Access Compliance Report

Public Rights-of-Way

(Pedestrian Signals)

Intersection ID: N/A	Main Street:	Cross Street: N/A	Location: N/A
ADA ID: 96F35FF5AF5F	Signal Type: One Push Button-Non APS	Overall Compliance: No	Severity Score: BTN 1: N/A BTN 2: N/A No BTN: N/A
Codes/Mitigation Info/Possible Solution		Field Measurements/Component Compliance

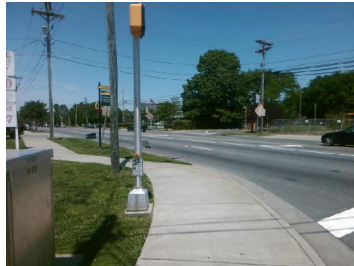
PROW/ADA: TMUTCD 4e.08, R404.2

Yes	B 1 Clear Xing Direction?	ClearlyMarked	N/A	B 2 Clear Xing Direction?	N/A
	B 1 Crossing Direction	To E		B 2 Crossing Direction	N/A
No	B 1 DistanceTo XWalk (in)	112.0	N/A	B 2 DistanceTo XWalk (in)	N/A
No	B 1 DistanceTo Curb (in)	85.0	N/A	B 2 DistanceTo Curb (in)	N/A
Yes	B 1 Diameter (in)	2.0	N/A	B 2 Diameter (in)	N/A

Possible Solutions: Replace Signal Push Button With APS Button on New Post. Remove & Relocate Sign.
